CBE, Sierra Club, Center, ForestEthics et al. Comments on the Revised Draft Environmental Impact Report for the Phillips 66 Company Rail Spur Extension and Crude Unloading Project

Expert Report of Phyllis Fox on the Revised Draft Environmental Impact Report for the Phillips 66 Rail Spur Extension and Crude Unloading Project, November 2014.

Phillips 66
Rail Spur Extension
and Crude Unloading Project

November 24, 2014

Figure 1
Distillation Yields of Conventional and Canadian DilBit and SynBit

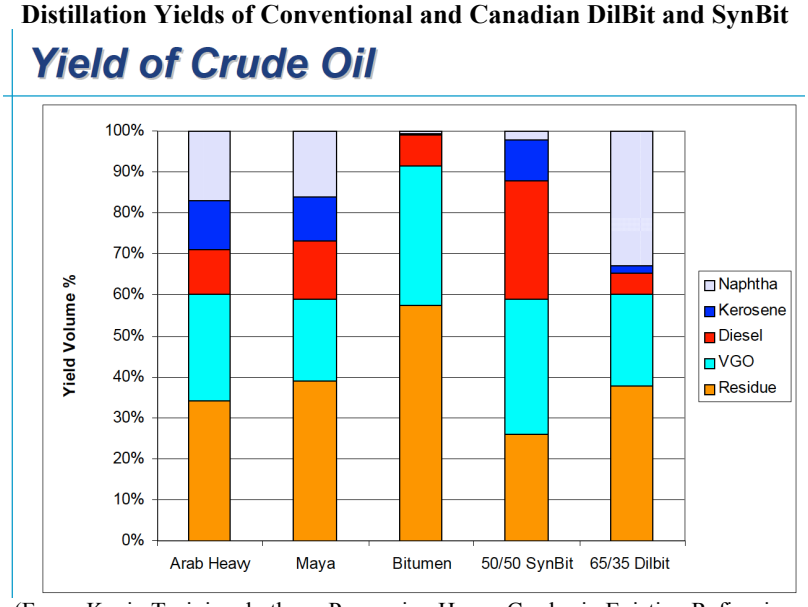
DilBits are sometimes referred to as "dumbbell" or "barbell" crudes as the majority of the diluent is C_5 to C_{12} and the majority of the bitumen is C_{30}+ boiling range material, with very little in between.[27] This means these crudes have a lot of material boiling at each end of the boiling point curve, but little in the middle. The 65/35 DilBit bar in Figure 1 indicates that these crudes generate about twice as much "naphtha" as the heavy crudes they would replace.

Figure 2
Distillation Yields of a Conventional Heavy Crude (Arab Heavy) and DilBits

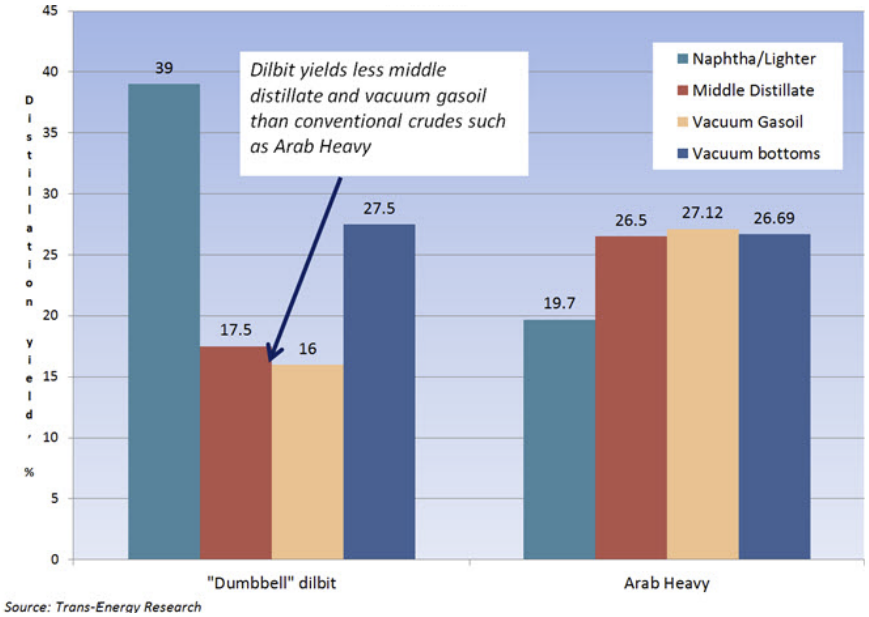
This is further confirmed by a different distillate yield bar chart from another source in Figure 2. This figure likewise confirms that switching from a heavy crude to a DilBit crude would roughly double the amount of naphtha distilled from the crude, from 19.7% to 39% and decrease gas oil from 27% to 16%. Additional amounts of both naphtha and gas oil would be produced by cracking the vacuum bottoms in the coker.

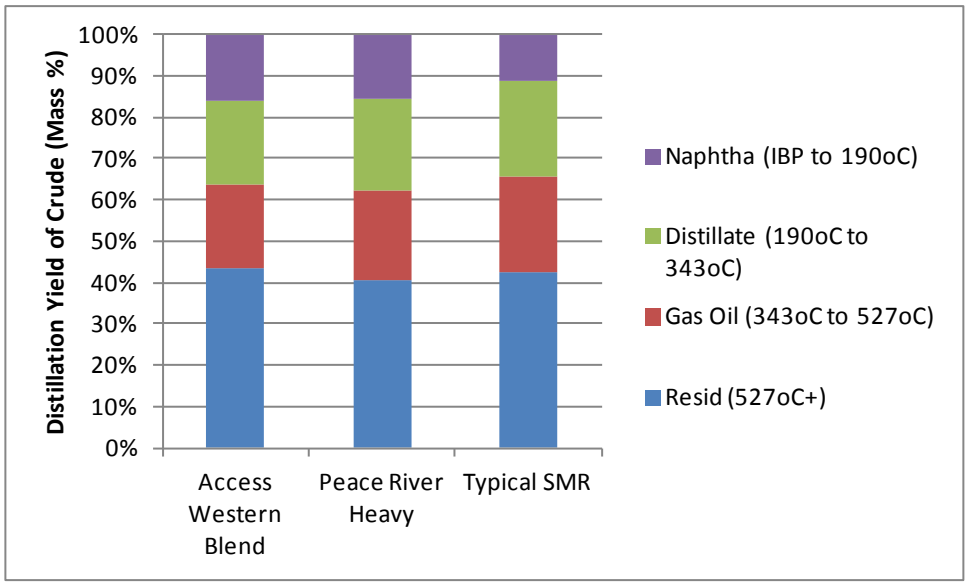
The comment also makes the argument that with a switch to tar sands the SMR would be producing more Naphtha (i.e., pressure distillate) based upon general crude data that does not reflect the actual crude mix being run by the SMR.

The figure below shows the breakdown of the yield for the crude mix currently being run by the SMR compared with the two dilbit crudes evaluated in the

This shows that the amount of naphtha, distillate, gas oil, and resid for the two dilbit crudes evaluated in the RDEIR are very similar to the typical composition of crude that is currently processed at the SMR. This data would indicate that the amount of naphtha (i.e., pressure distillate) and gas oils produced at the SMR with the use of the dilbits would not increase with the change in crude. Therefore, the amount shipped to the Rodeo Refinery would not increase as a result of the change in crude oil slate.
